Attorney's Docket No.: 07977-093002

REMARKS

FIG. 2A

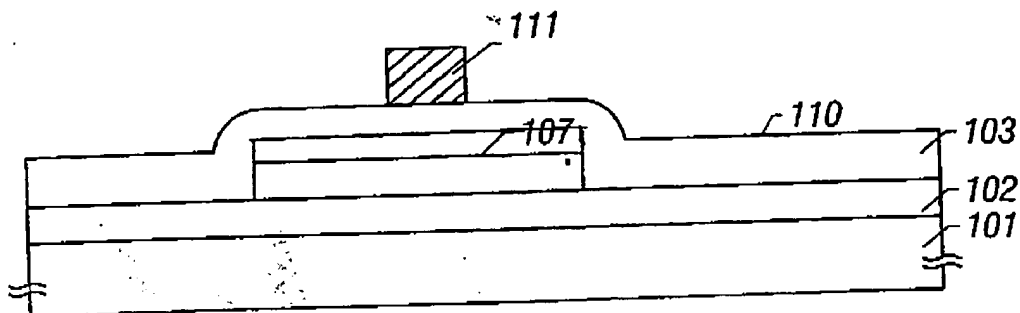
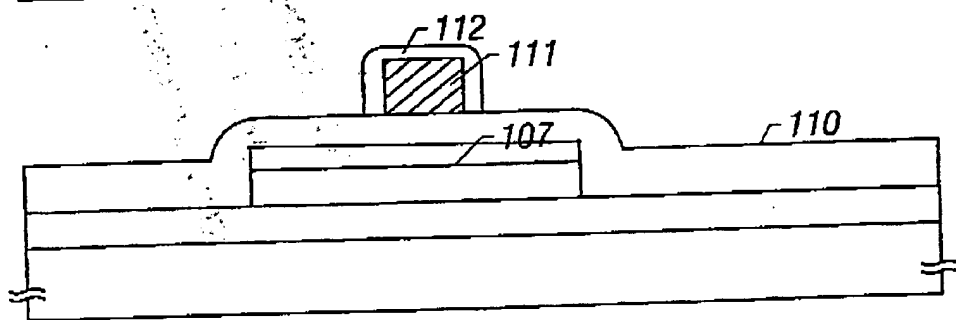
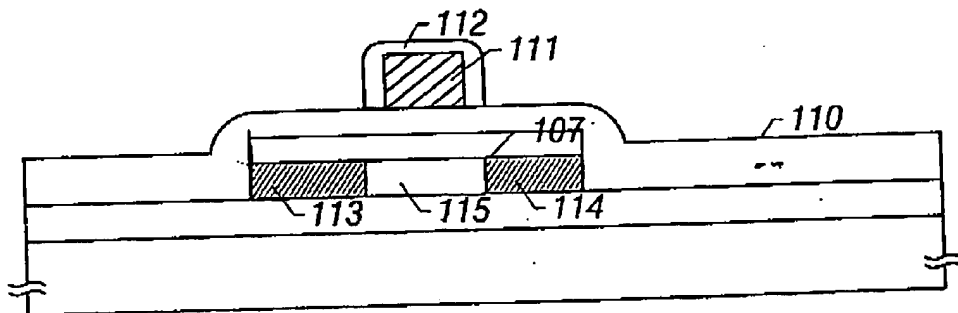
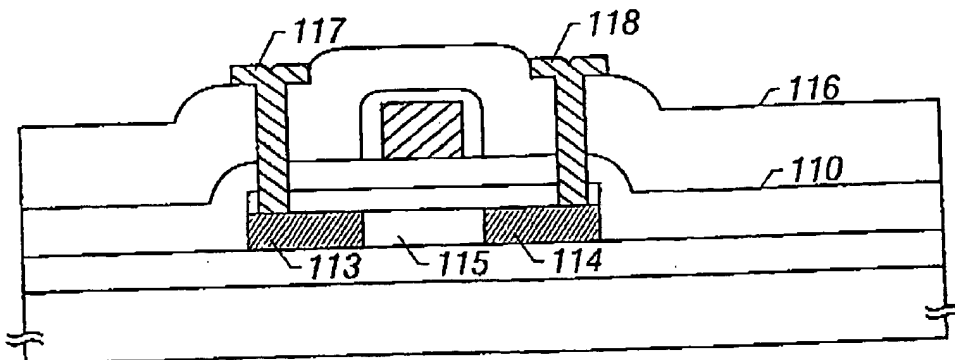
The drawings stand rejected under rule 83. In response, Figures 2A - 2D have been amended to clarify their subject matter and to show the claimed invention more clearly.
